N1092E-01

Modification Recommended Service Note

N1092E DCA-M Sampling Oscilloscope (Dual Optical, Dual Electrical Channel)

Replace the left front panel overlay that shows the new clock input level at 1.4 Vp-p Max.

Figure 1 Updated overlay - should say 1.4 Vpp Max

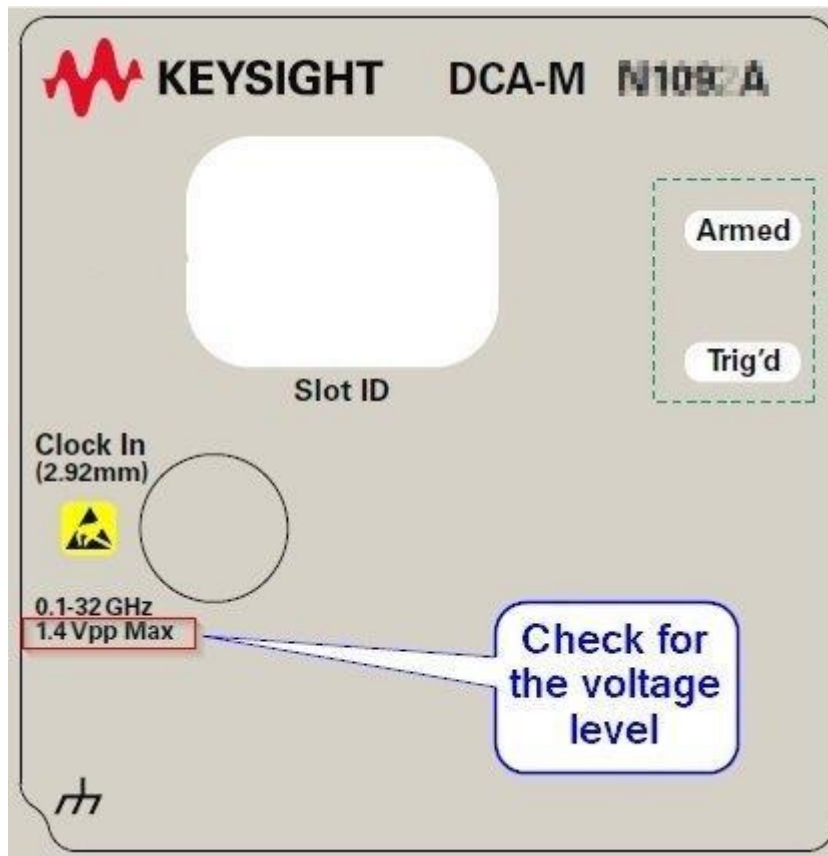
In May 2018, the clock's input port maximum signal voltage changed from 2.0 Vp-p (old value) to 1.4 Vp-p (new value). This is very sensitive circuitry and this change provides additional margin to reduce risk of damage to the instrument.

New instruments shipping after this change has the new left front panel overlay with this updated information, see Figure 1 below.

If the front left panel overlay shows 2 Vp-p (old value), remove the old overlay and replace it with the new overlay that shows 1.4 Vp-p (new value). If the customer has added any asset tags, or other customer information to the old left front panel overlay, it is recommended to send back the old overlay to the customer after it has been removed.
